Advertising Safety Guidance Form – ASGF

Site Ref 01 - Camden High Street
A. Jennings
A. McDonald
04 August 2015

Location Description: Site located on one way high street along side tube station

B: Sketches

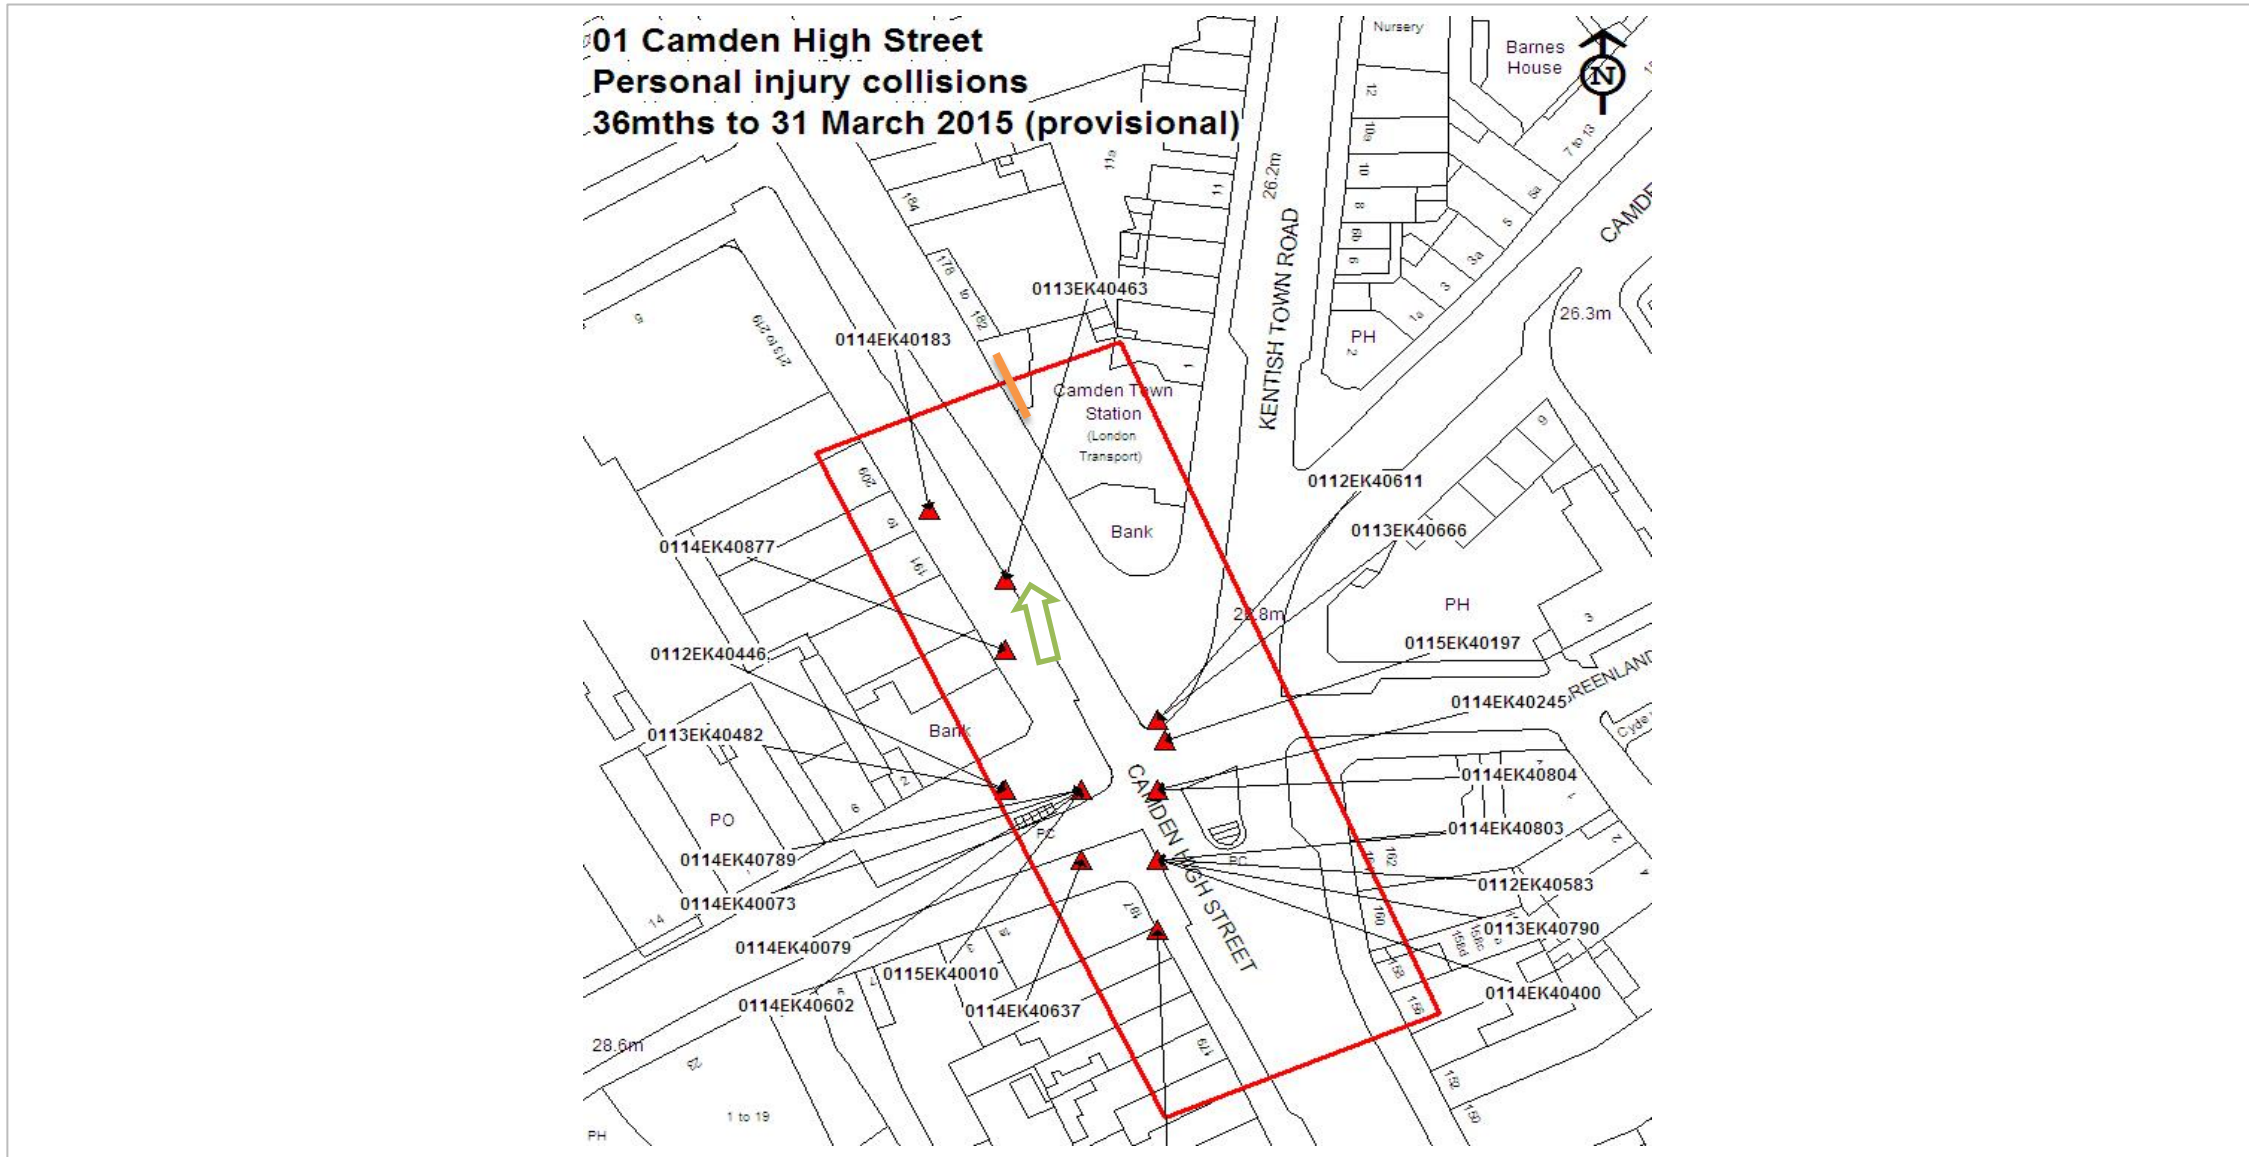
Issue	Comments	Checked	Issue	Comments	Checked
<p>Traffic signals: Are there signals close to the advert? Does the advert obscure them? Will the advert be seen behind the signals? Will the advert cause the driver to look a significant distance from the signals?</p>	<p>The existing sign is 50m from the traffic signals and not clearly visible from that location</p>		<p>Maintenance / Installation: Can the advert be serviced safely (cleaning, poster change etc)? Is there a safe place for vehicles to stop and service the site?</p>	<p>A restricted loading area is located a short distance from the site would provide an area for vehicles to stop between 830am and 630pm Monday - Friday.</p>	
<p>Traffic signs: Are there traffic signs close to the advert? Are they safety critical? Does the advert obscure them? Will the advert be seen behind the signs? Will the advert cause the driver to look a significant distance from the signs?</p>	<p>Loading restriction and speed limit signage is located within 10m of the site. The proposed ADU would not have any affect on the traffic signs.</p>

<p>Footways Will the advert impact on pedestrians or cyclists? This is particularly relevant for signs located in the footway. What is the remaining footway width and pedestrian flow? Does the advert effect pedestrian sightlines?</p>	<p>Pedestrian and cyclists flows and sight lines would not be affected</p>				
<p>Any other Visibility and Sightline issues for road users?</p>	<p>No other issues</p>

An area south of the site has been assessed as Camden High Street has one way traffic heading north. 21 collisions have been reported in the last 36 months of available collision data. Most of the collisions are located at the junction 50m south of the site. From the junction drivers have a limited view of the existing board as it is at 90 degrees to the road and a ADU would therefore have no impact on the safety of this junction. Closer to the site 3 collisions have been recorded. 2 of these collisions involved cars and crossing pedestrians and one a car and motor cycle in a rear end shunt collision. One resulted in serious injury and two in slight injuries.

Based on the above analysis, should the proposed advertisement be permitted in its current form? If not, why not?					
<p>It is recommended this is suitable for a digital advertising board.</p>					
Do you recommend that a safety audit is carried out? No					
If the assessor is of the opinion that the advertisement should not be permitted, are there changes that could be made to the proposal that would address the above concerns? This may include changing the type, size, content or orientation of the display, or through the use of appropriate planning conditions.					
Assessed by:	Andrew Jennings	Signed:		Date:	4.8.15
Checked by:	Andy McDonald	Signed:		Date:	12.8.15
